PRODUCT CHANGE NOTIFICATION

PCN No.: PCN-202508-027	**PCN Doc No.:** EC-20250804-PCN-18	**Date Issued:**	8/12/2025
Part Number or Series: PH1-XX-TA-SMT-A		**PCN Effective Date:**	8/12/2025
Customer: (If applicable)		**P/O No.: (If applicable)**	Not affected
Type of Change:	■ Mfg location Change / Qualification / Country of Origin (COO) ■ Design Change / Data Sheet Spec Change	**Last Time Buy Date:**	Not affected
Traceability Marking/Date code: No change		**Last Time Ship Date:**	Not affected
Replacement Part Number: PH1-XX-TA-SMT-A-Y		**Sample Availability Date:**	Not affected

China Part	Malaysia Part

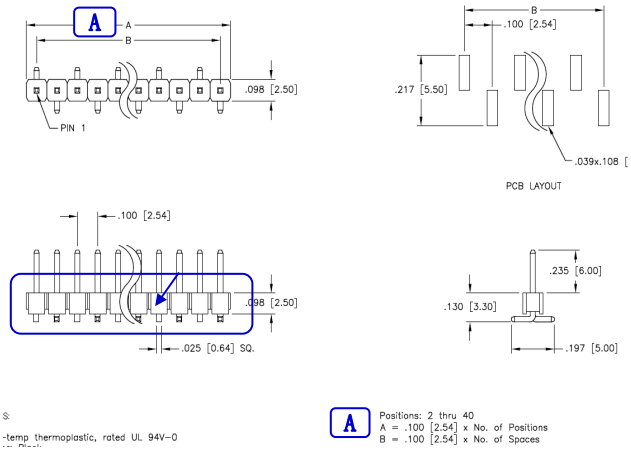
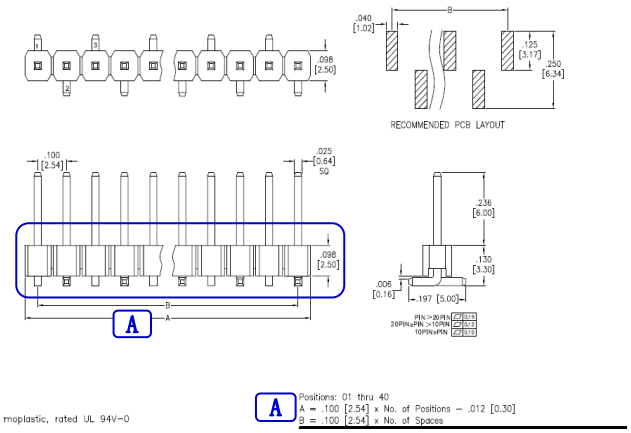
Impact of Change: P/N change, There are slight differences in appearance and size.

Original China Part: 1. Appearance ~ As shown in the above picture; 2. Size: A) A=.100[2.54] * No. of Positions;	New Malaysia Part: 1. Appearance ~ Slightly different; 2. Size: A) A=.100[2.54] * No. of Positions - .012[0.30]
